Response to review of referee #1

William Santini, Benoît Camenen, Jérôme Le Coz, Philippe Vauchel and Jean-Michel Martinez

15/03/2019

Response to review of referee #2

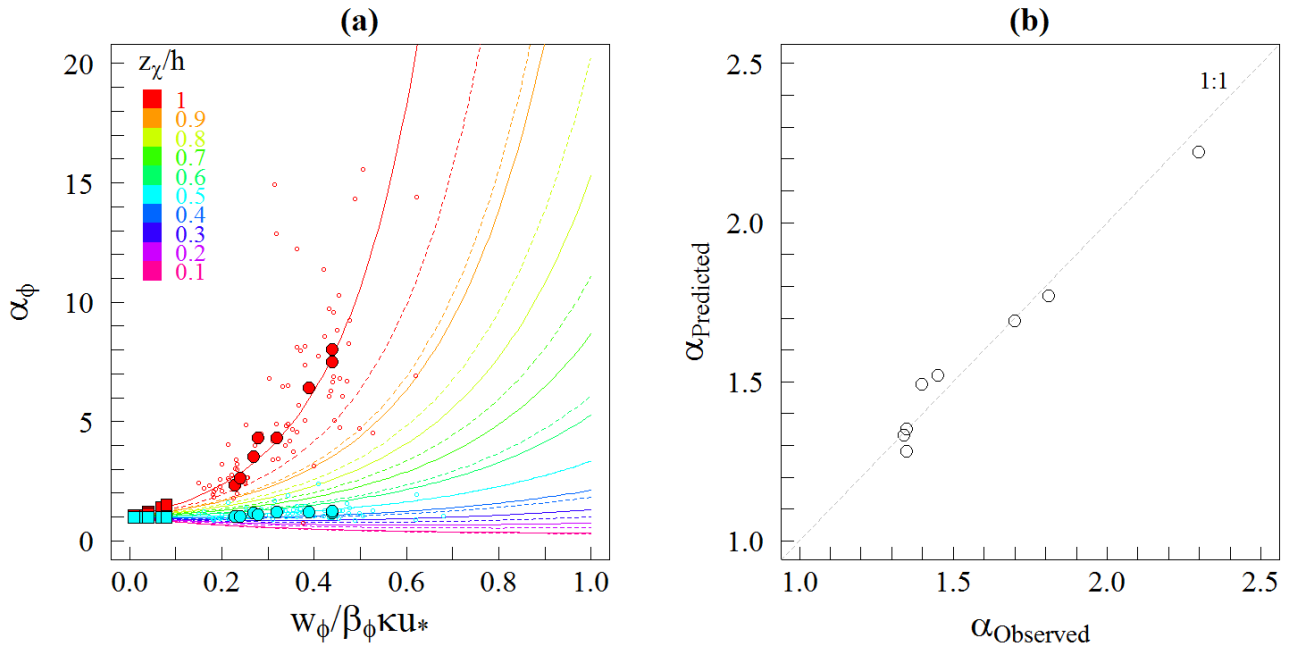
- Figure 7, caption: What is meant by “observed” and “measured” values here?

For the ratios α , all the terms “measured” were replaced by “observed” in the ms to avoid any confusion.

For each site, mean α_f and α_s were computed according to Eq. 17 with the mean parameters given in table 2. Then, “predicted α ” were calculated from Eq. 15 ($\alpha = X_f \alpha_f + X_s \alpha_s$), by considering the mean X_f and X_s values also given in table 2 and calculated from the concentration measurements. Finally, the “predicted α ” are compared in Fig.7 with the “observed α ”, i.e. the mean ratios between index and average total concentration, observed at each site.

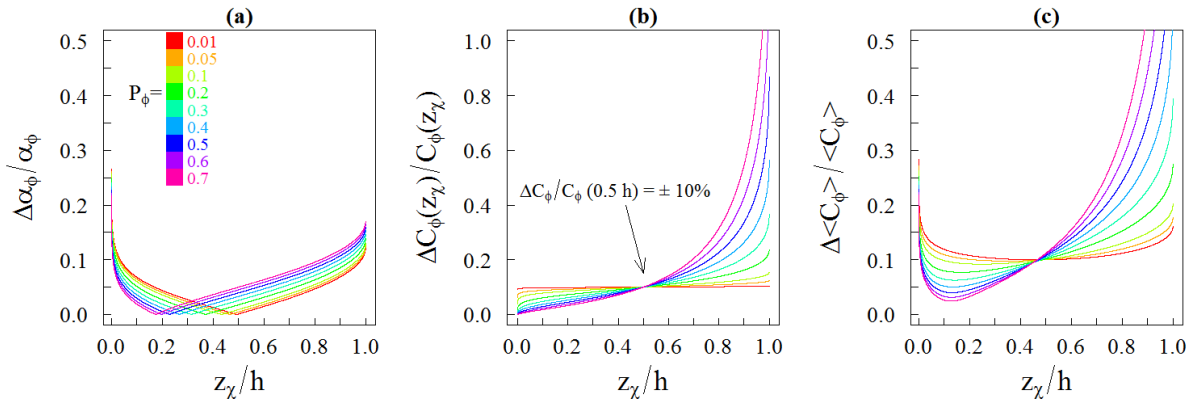
For example, in the caption for figure 11 it might be good to remind readers what h stands for. Also, there are a lot of stand alone sentences rather than paragraphs throughout the manuscript. Possibly some formatting thought-out could be useful.

- **Caption for figure 11:** “(a) Relative error of the predicted α_ϕ according to the relative height z_χ/h of the index sampling, for various Rouse numbers P_ϕ . (b) Relative error of the concentration sampled, inferred from the Zagustin model and assuming $\frac{\Delta C_\phi}{C_\phi}(z_\chi = 0.5 h) = \pm 10\%$. (c) Relative error on $\langle C_\phi \rangle$ as a function of z_χ/h .”
